Review 1

Peninsula View Urban Renewal, LLC
Preliminary and Final Major Site Plan
Application P-26-002

Penn View Redevelopment Plan

July 8, 2026

Illustration 2. Architect's Rendering of Route 440 Façade with Retaining Wall Planters

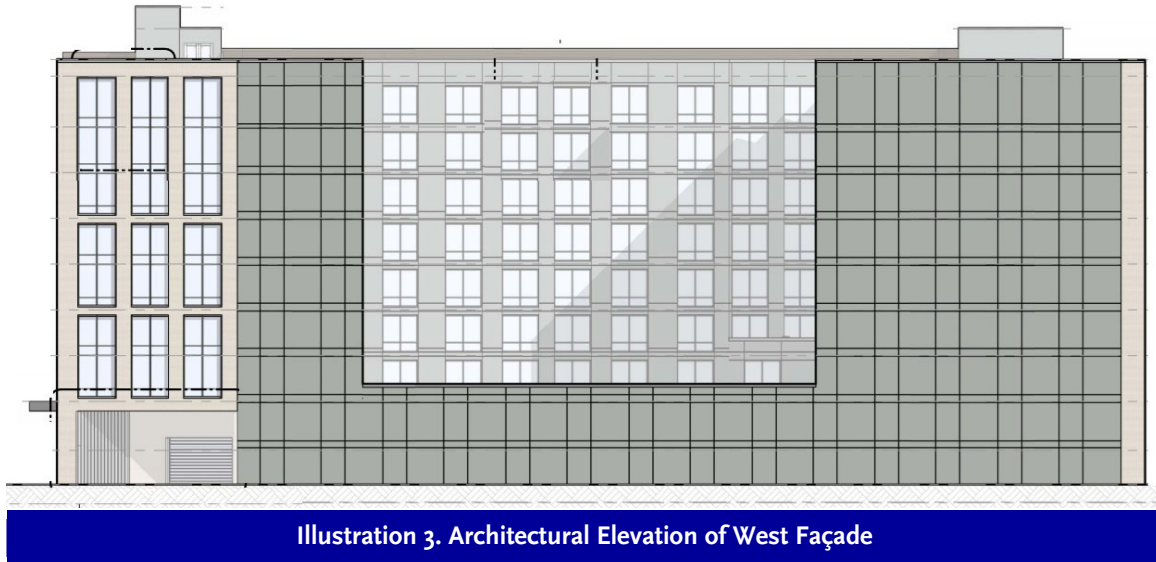
- 7.6. **Fences and Walls.** §3.3.3.J.1 prohibits any fence or wall on a side or rear property line greater than eight feet in height. Modular block retaining walls are proposed along the property's Route 440 frontage, on either side of the entrance driveway and at the end of E. 31st Street that range in height up to six feet. **The plan complies, although City Council approval is required to construct the wall in the E. 31st Street right-of-way.**

- 7.7. **Wall Planters.** The site plan specifies a block retaining wall with embedded planter box along the Route 440 frontage and on either side of the entrance driveway. No detail is provided and no plantings noted in the landscape plan. **The applicant should verify the intent to use planters integrated into the retaining wall and the plans should be revised accordingly. The block should be architectural masonry units.**
